Monthly Specification Update

Intel® Server Boards S2600WP Family
Intel® Server Systems H2000WP Family

Intel Order Number G64830-003

October, 2012

18. Chassis sag to 2.0 mm when fully loaded in rack

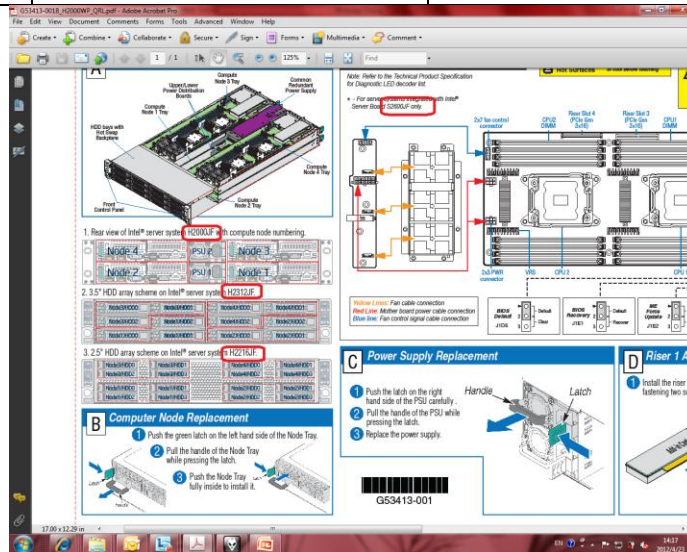
Problem Chassis fully loaded (34kg) will sag about 2.0 mm when installing in rack

Implication The max sag (~2.0mm) will happen at the rear of the chassis.

Status This issue may be fixed in future chassis build.

Workaround leave 1U space under H2000WP chassis when install in the rack or load system device shorter than 21" under H2000WP chassis adjacently.

19. Incorrect picture titles in Chassis Quick Reference

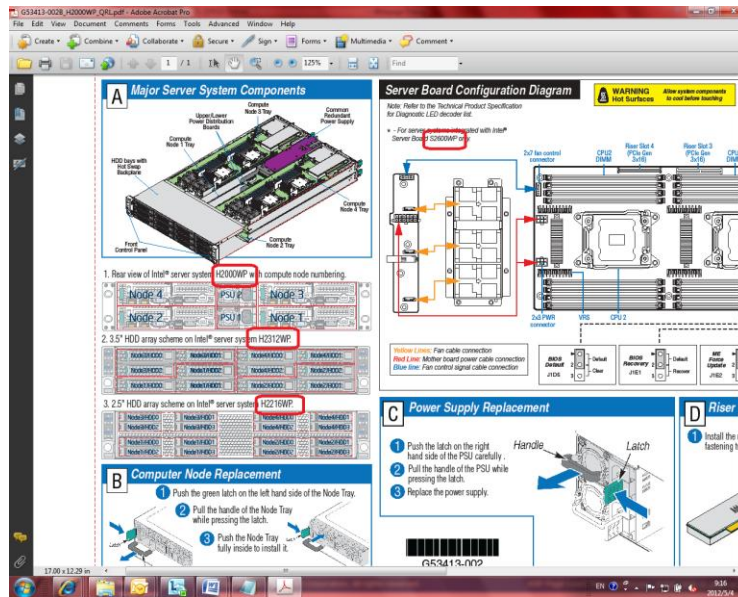
Problem The Intel® Server System H2000WP family Chassis Quick Reference(document ID G53413-001) has 4 incorrect picture titles as shown below. The correct title name should be “H2000WP”, “H2312WP” “H2216WP” and “S2600WP”. All schemes and configuration diagrams are correct for H2000WP. The impacted servers systems are listed below. The updated Chassis Quick Reference (document ID G53413-002) has fixed this problem. The impacted server systems are list in the table

The Chassis Quick Reference with incorrect picture titles

The Chassis Quick Reference with updated picture titles

- Implication The picture tiles do not match the pictures.
- Status This issue was fixed with G53413-002.
- Workaround None.
